SWIM PROJECT PROFILE		Pilo No. : 166
Regist. No. : Agency No. : BSWM-80	Name: CAMBURAY SWIP	
Region: 4	Province: OCCIDENTAL MINDORO	Municipality: SAN JOSE
Present Status: 1. Pro-F/S() ② F/S(1985) ③ D/D(1985)		
Purpose: Major : Irrigation Incidental : IF, FC, WM		
Project Feature:

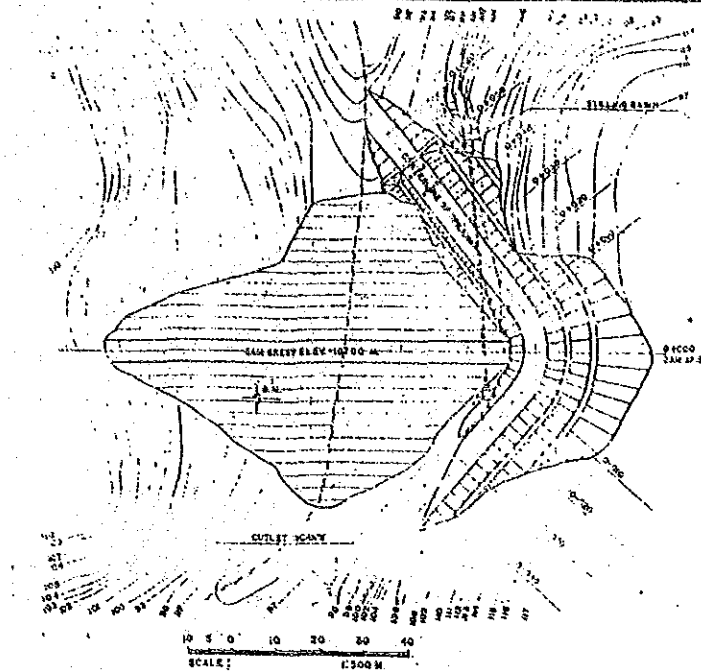
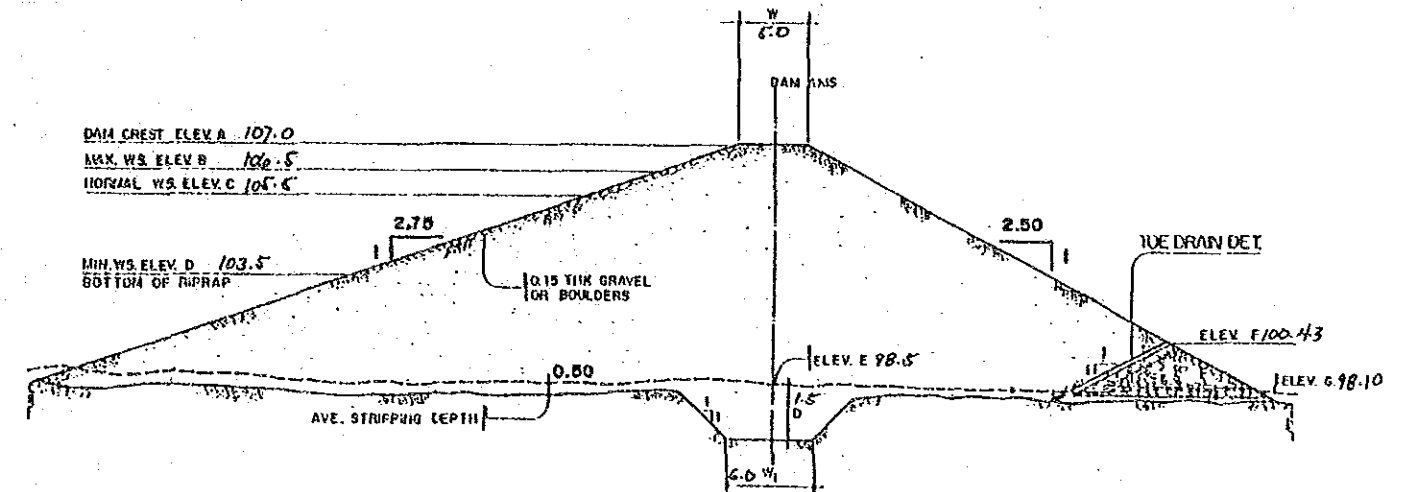
2. Planning Environmental conservation plan is not formulated.		
3. Design Depth of core trench shall be modified during construction. Stability of upstream slope of the dam shall be checked. Alignment of the spillway shall be re-studied. Weir shall be provided in the spillway.

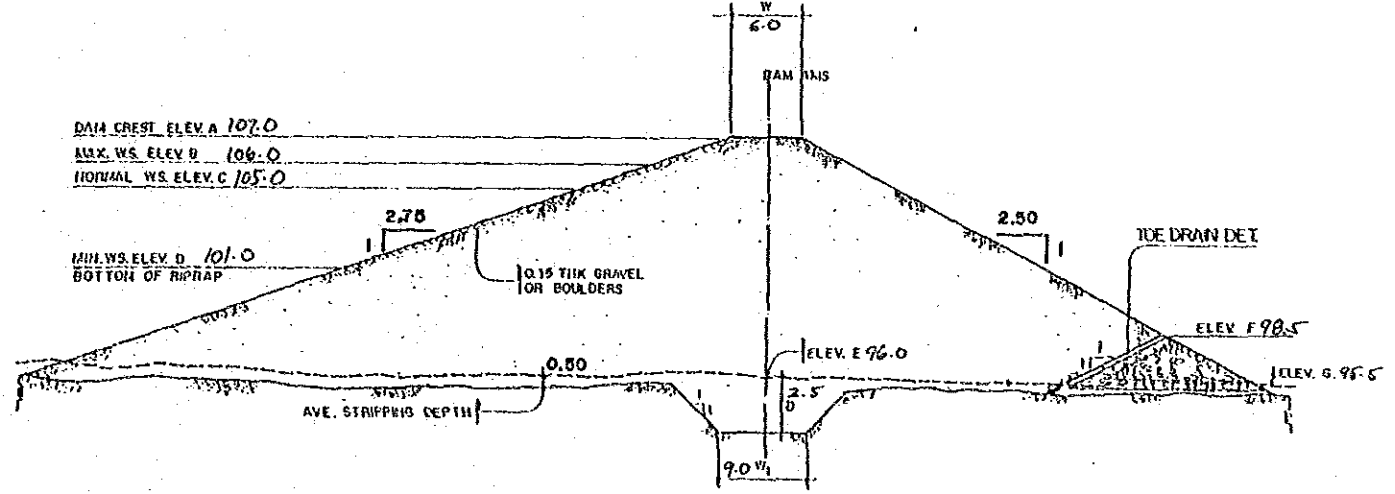
2. Planning Environmental conservation plan is not formulated.		
3. Design Depth of core trench shall be modified during construction. Stability of upstream slope of the dam shall be checked. Center line of the spillway shall be shifted to right side. Weir shall be provided in the spillway.

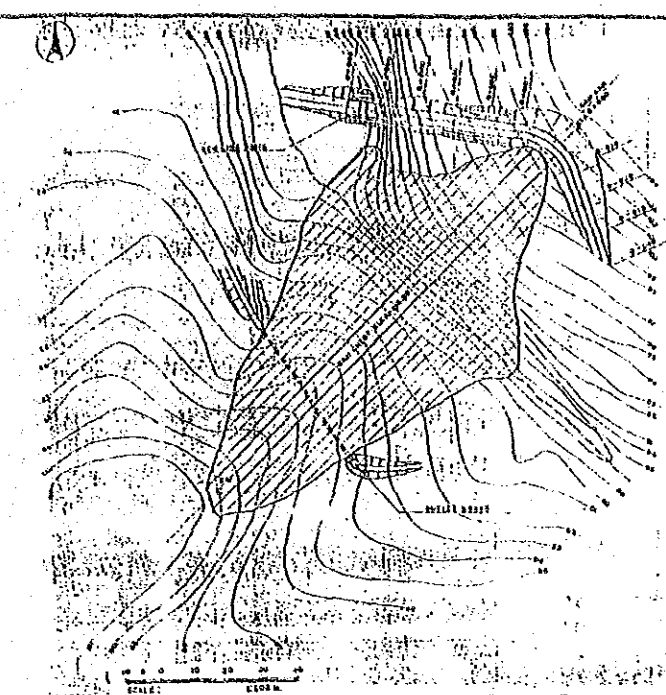
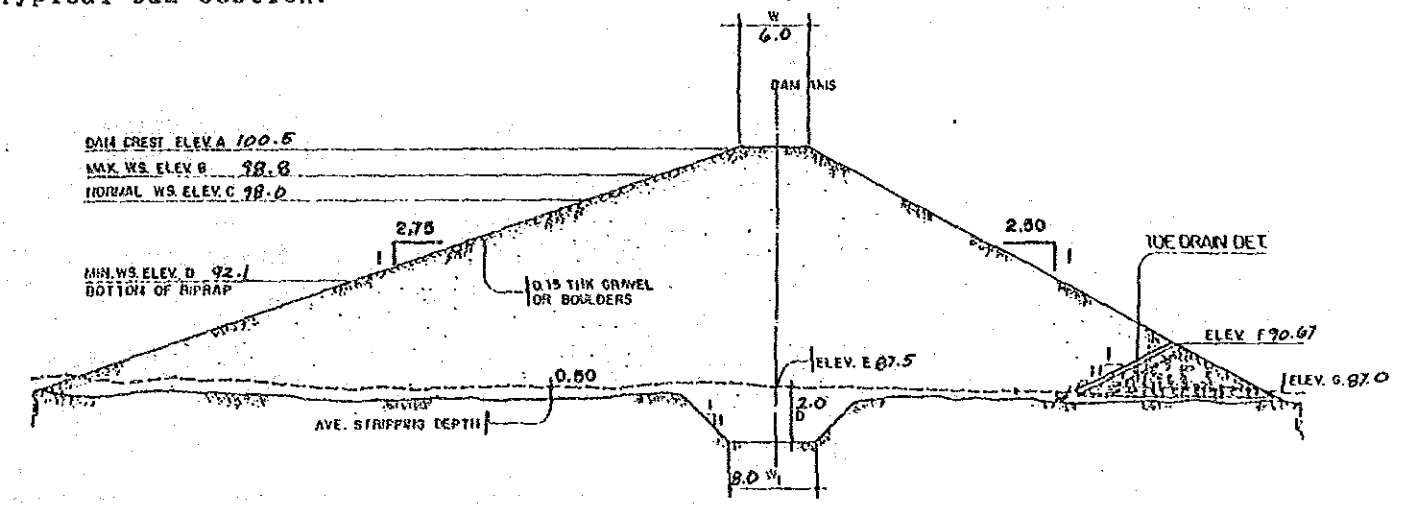
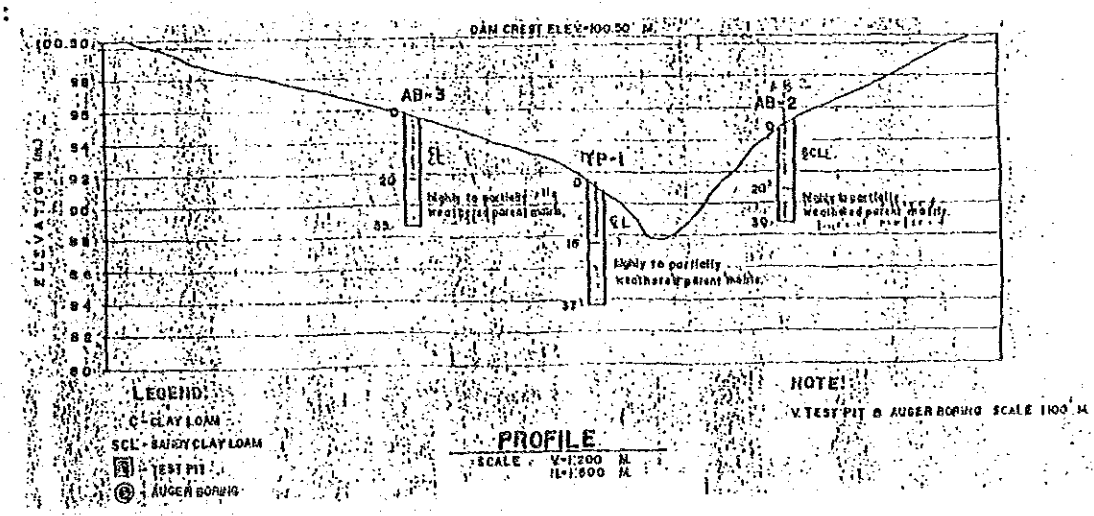
2. Planning Environmental conservation plan is not formulated.		
3. Design Depth of core trench shall be modified during construction. Stability of upstream slope of the dam shall be checked. Weir shall be provided in the spillway.

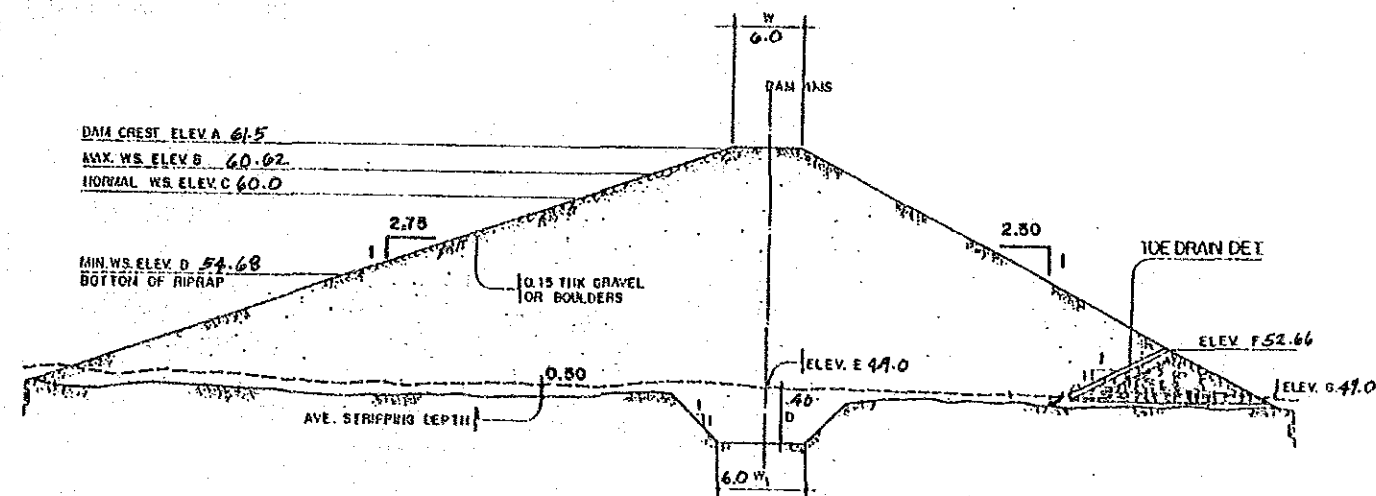
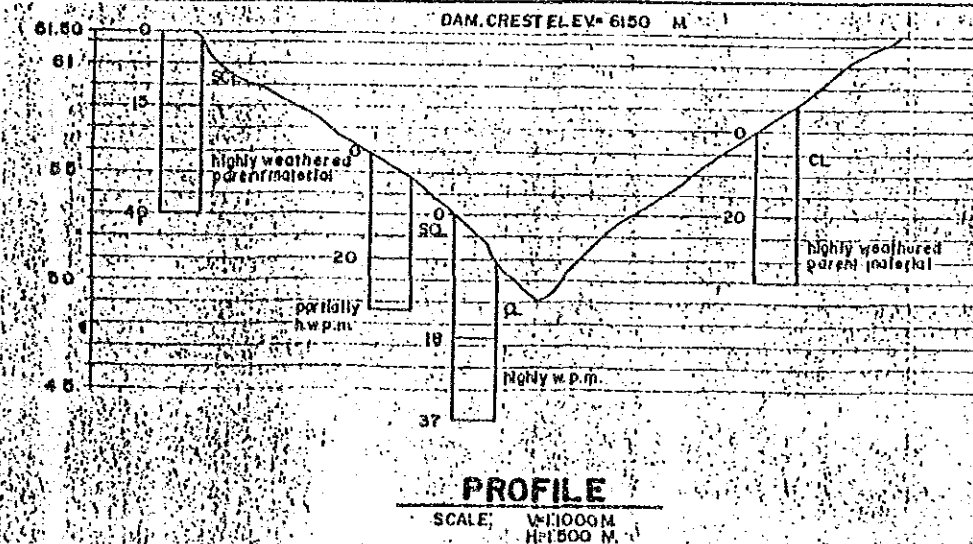
2. Planning Environmental conservation plan is not formulated.		
3. Design Depth of core trench shall be modified during construction. Stability of upstream slope of the dam shall be checked. Weir shall be provided in the spillway. Center line of conduit is recommended to be straight.

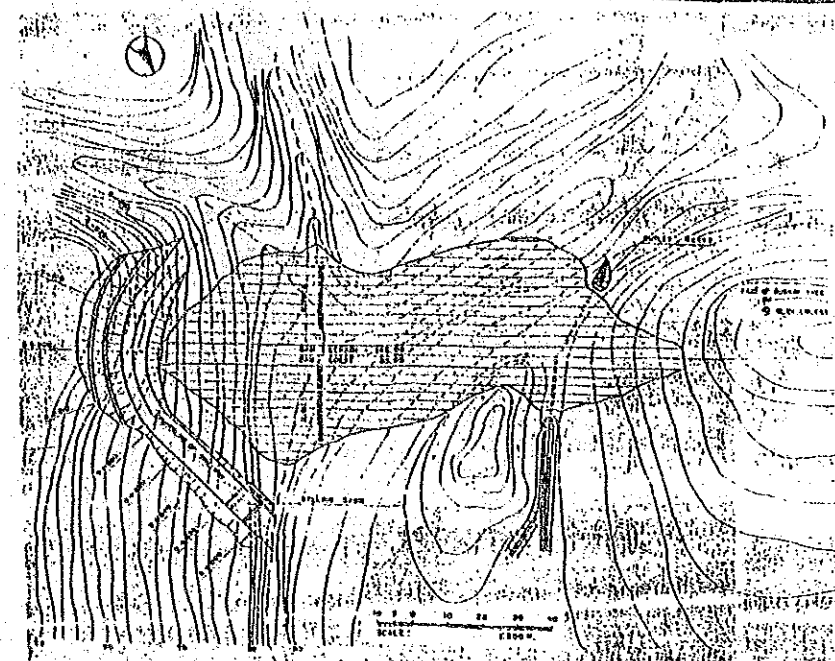
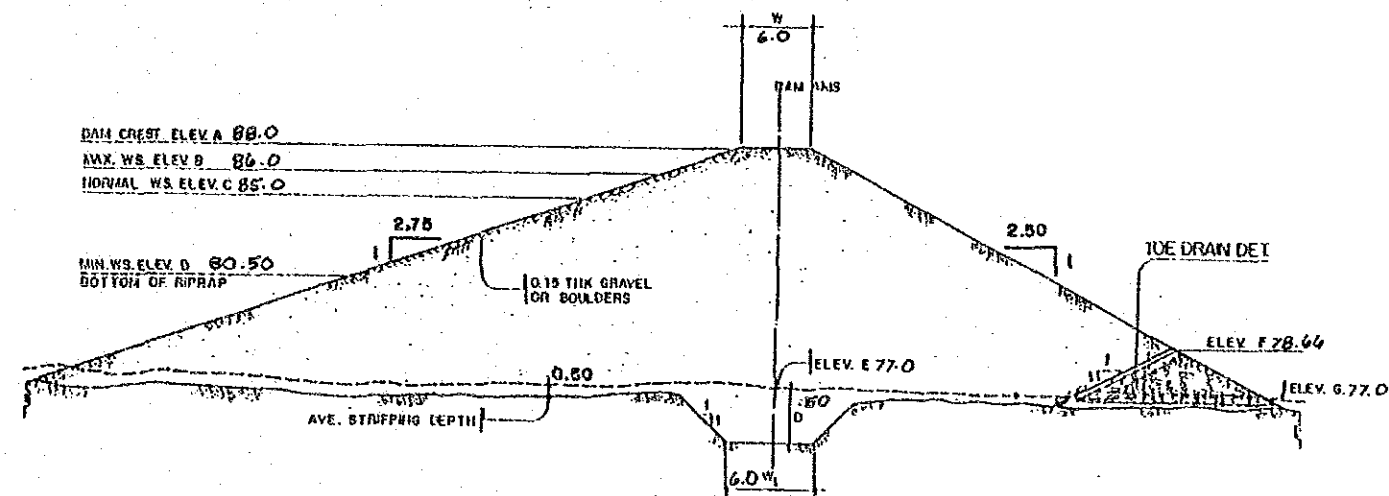
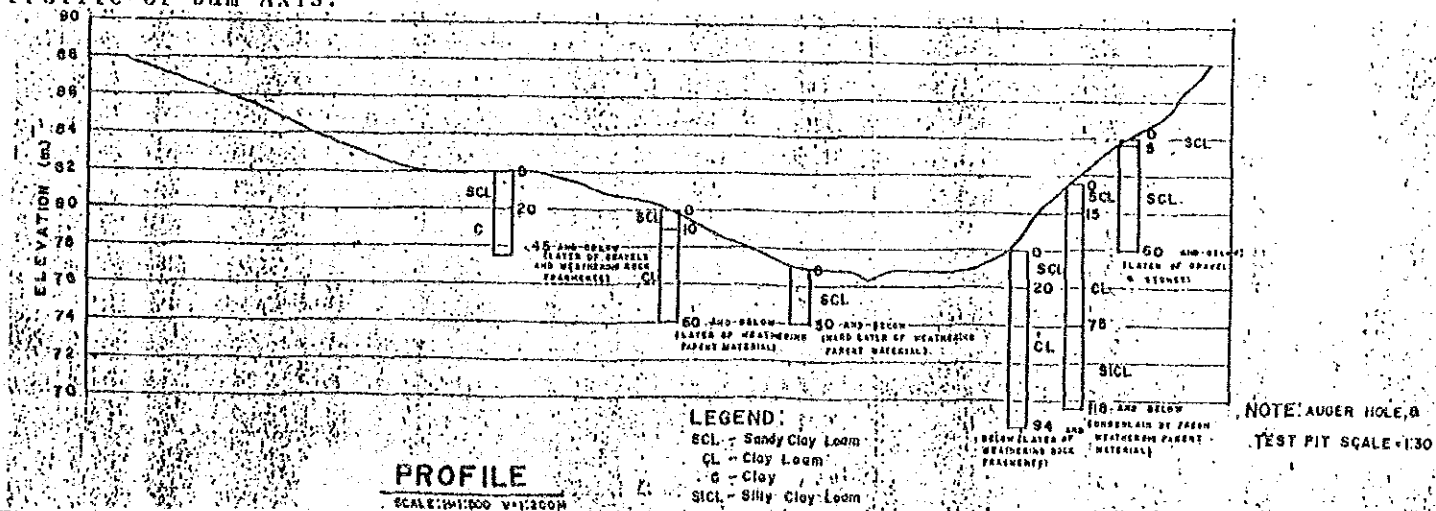
2. Planning Environmental conservation plan is not formulated.		
3. Design Depth of core trench shall be modified during construction. Stability of upstream slope of the dam shall be checked. Weir shall be provided in the spillway. Center line of conduit is recommended to be straight.

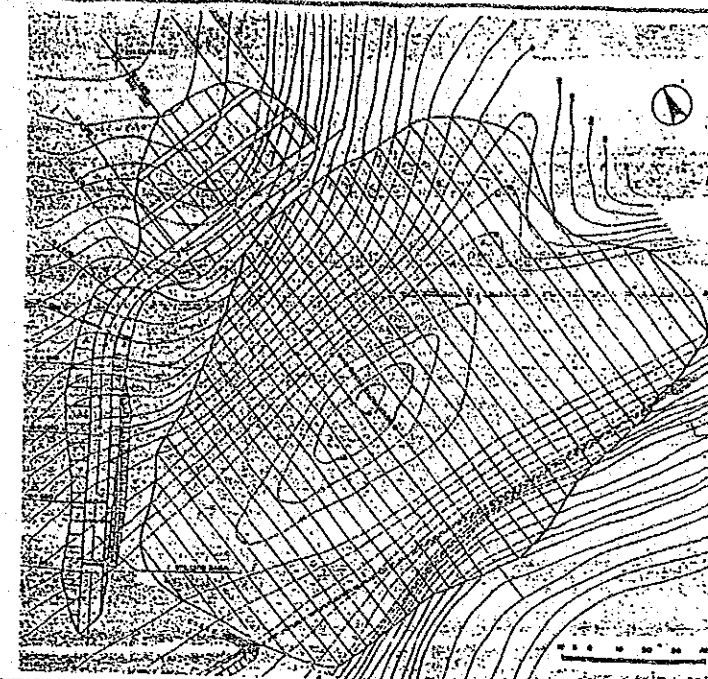
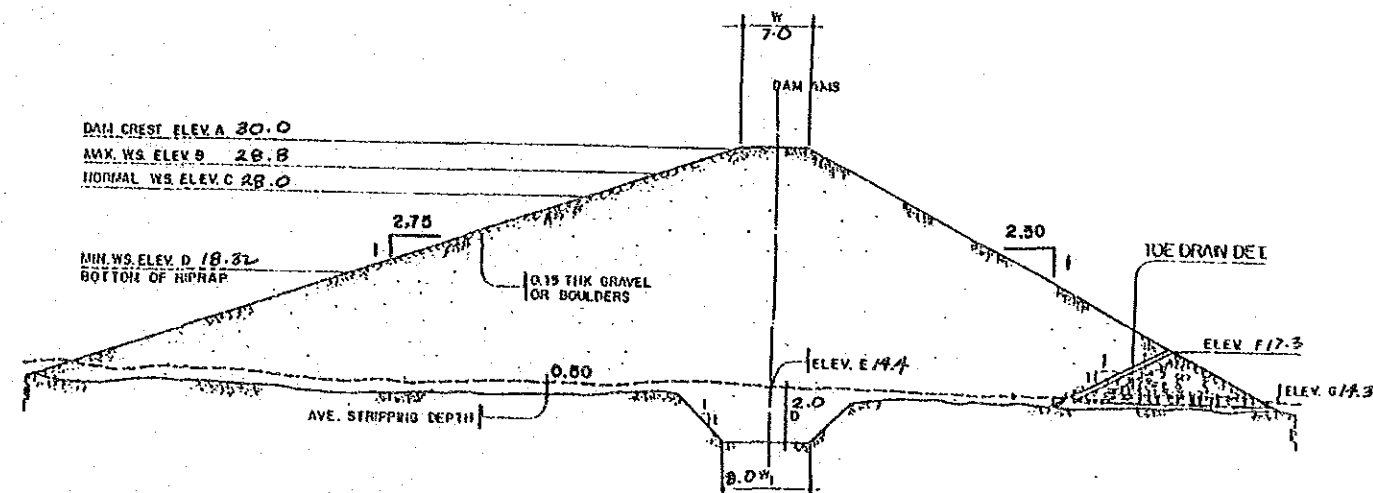
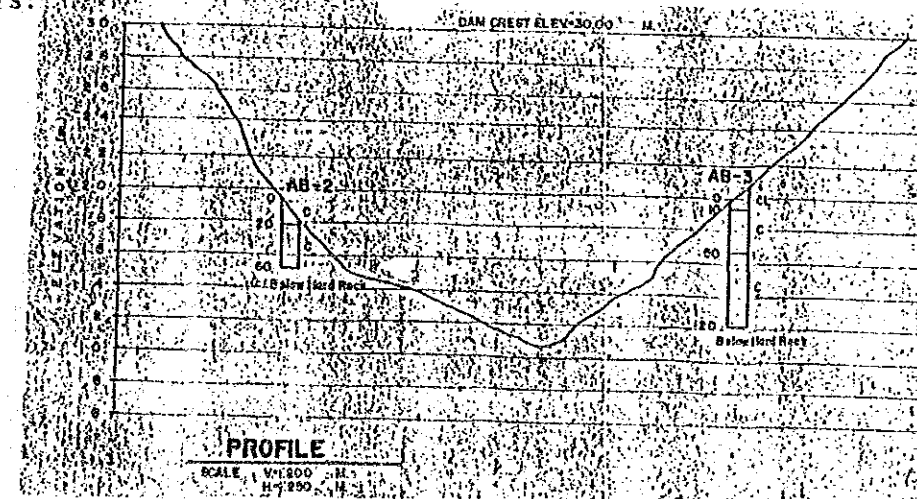
2. Planning Environmental conservation plan is not formulated.		
3. Design Depth of core trench shall be modified during construction. Stability of upstream slope of the dam shall be checked. Design discharge shall be estimated based on 100 year' flood or more. Weir shall be provided in the spillway.

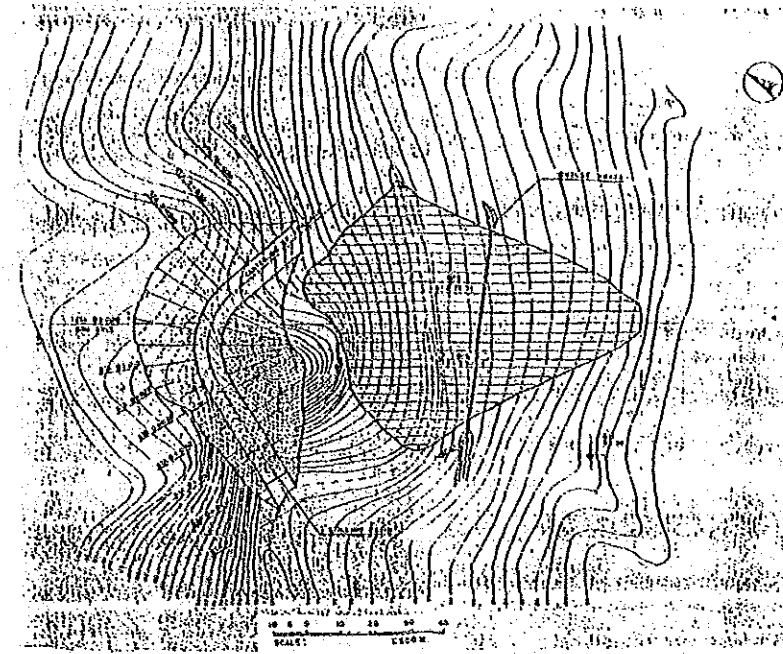
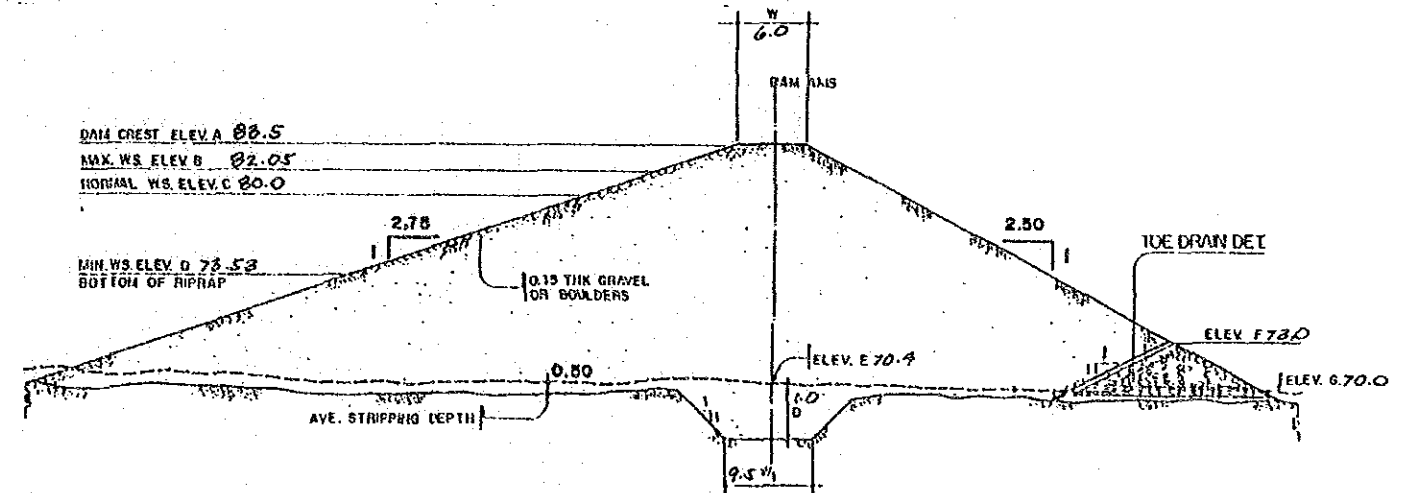
2. Planning Annual production of inland fishery is over-estimated. Environmental production plan is not formulated.		
3. Design Depth of core trench shall be modified during construction. Stability of upstream slope of the dam shall be checked. Center line of supercritical flow portion shall be straight. Weir shall be provided in the spillway.
